Revised SE01-003 SOFIA Image Size Requirement

Proposed changes: Observatory Image Quality: Image Size

Image Size

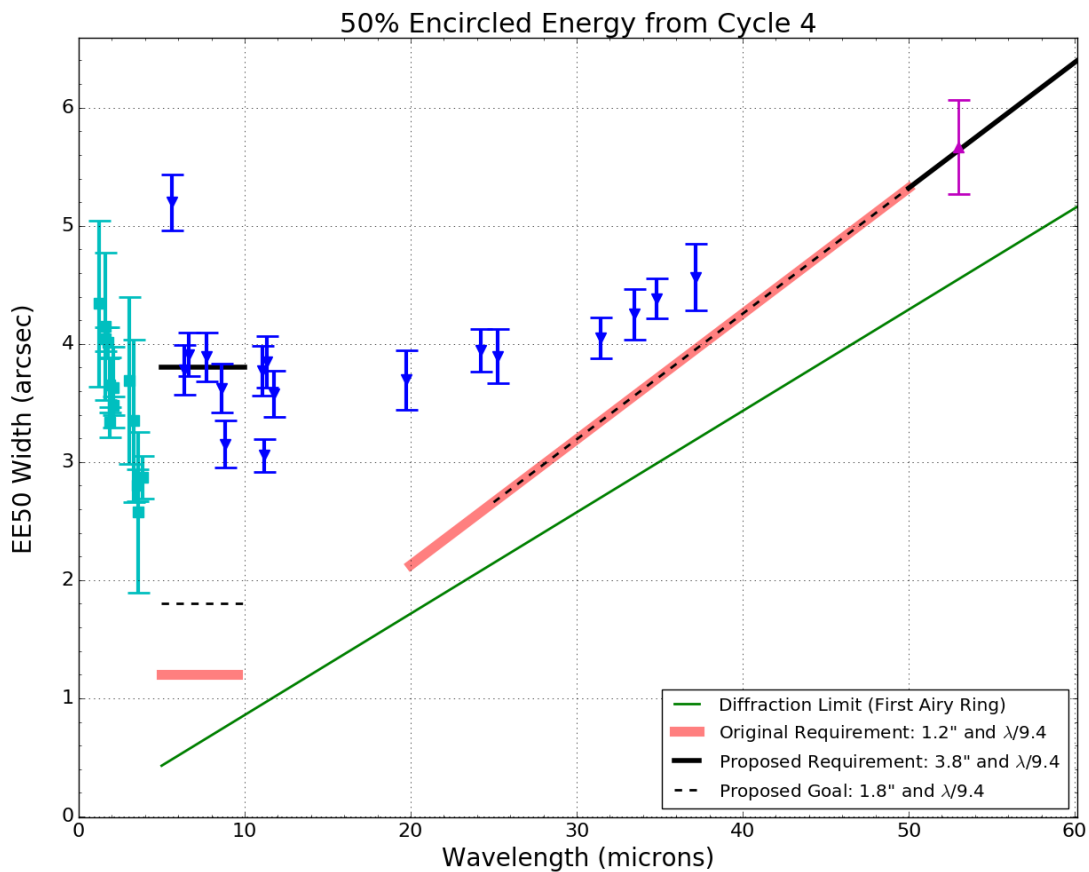
3.2.26: The SOFIA System shall produce point-source images in wavelengths of 5.0-10.0 microns with a diameter corresponding to 50% encircled energy of less than or equal to 3.8 arcseconds at an observing altitude of at least 41,000 feet and exposure times of at least one second, excluding the effects of the science instrument. A recommended goal is to produce images at wavelengths of 5.0-10.0 microns with a diameter corresponding to 50% encircled energy of less than or equal to 1.8 arcseconds

3.2.27: The SOFIA System shall produce point-source images in wavelengths of greater than or equal to 50 microns with a diameter (measured in arcseconds) corresponding to 50% encircled energy of less than or equal to the wavelength (in microns) divided by 9.4, at an observing altitude of at least 41,000 feet and exposure times of at least one second, excluding the effects of the science instrument. A recommended goal is to produce point-source images in wavelengths of greater than or equal to 25 microns with a diameter (measured in arcseconds) corresponding to 50% encircled energy of less than or equal to the wavelength (in microns) divided by 9.4.

- Existing requirement valid for $\lambda > 50 \mu\text{m}$, as HAWC data shows compliance
- Data from HAWC and aberration analysis by DSI suggest we are diffraction limited at > 50 microns already
